ADDENDUM NO. 1

DATE ISSUED: 4/1/2021

PROJECT NAME: 0408-2021 Network Cabling – Conroe Central Waste Water Treatment Plant

OVERALL SITE PLAN

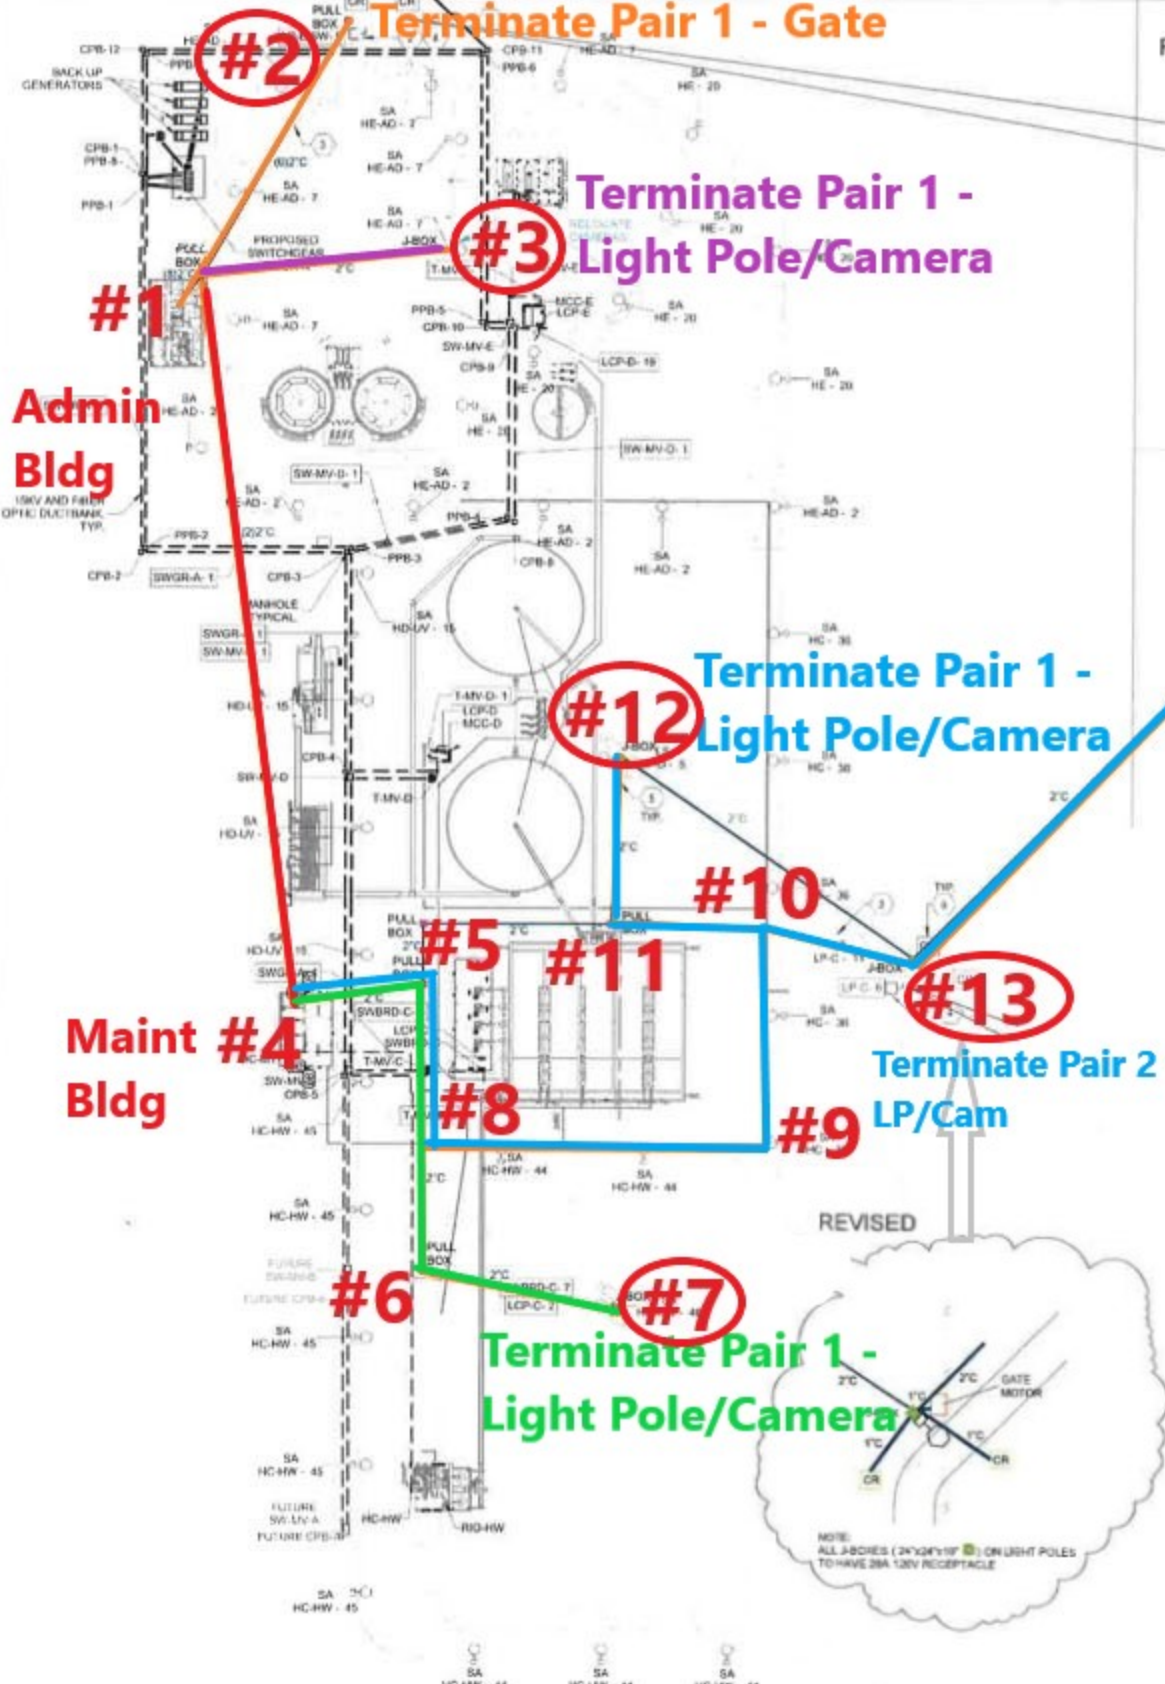
- Can you confirm the usage of OM3 fiber? It appears the longest portion of the cabling run is 3k feet long (~983 meters). Distance limitations for OM3 are 550m.
 - After research it is determined that single mode fiber is required. There will be 5 separate single mode fiber runs identified by color on the attached map.

- Can you verify the fiber lengths on the Site Plan? For example, it says from #4 to #5 is 86' and #5 to #6 is 68'; Point #5 to #6 is a significantly longer line on the drawing but shows to be shorter in the chart.
 - Fiber conduit lengths have been verified and updated on the attached map.

- Are points #8 and 10? going to be splice points or will the cable route from point #6 to #7 then back to #6 and on to point #8?
 - The attached updated map has been updated to reflect all points. There are no splices between the building and final termination points.

- #1 to #2 - 420' - Admin Bldg to Gate
- #1 to #3 - 214' - Light Pole/Camera
- #1 to #4 - 820' - Admin bldg to Maint bldg
- #4 to #5 - 86' #5 to #8 - 140'
- #6 to #7 - 176' - Light Pole/Camera
- #4 to #5 - 86' #5 to #8 - 140'
- #8 to #9 - 350' #9 to #10 - 168'
- #10 to #11 - 160'
- #11 to #12 - 140' - Light Pole/Camera
- Loop back from #12 to #11 - 140'
- #11 to #10 - 160'
- #10 to #13 - 160' - Gate/Camera
- #13 to #14 - 720'
- #14 to #16 - 240' - Gate
- #16 to #17 - 120' - Light Pole/Camera
- #17 to #18 - 320' - Gate/Camera

Each color represents one 12-strand single mode fiber.

○ Represents termination point
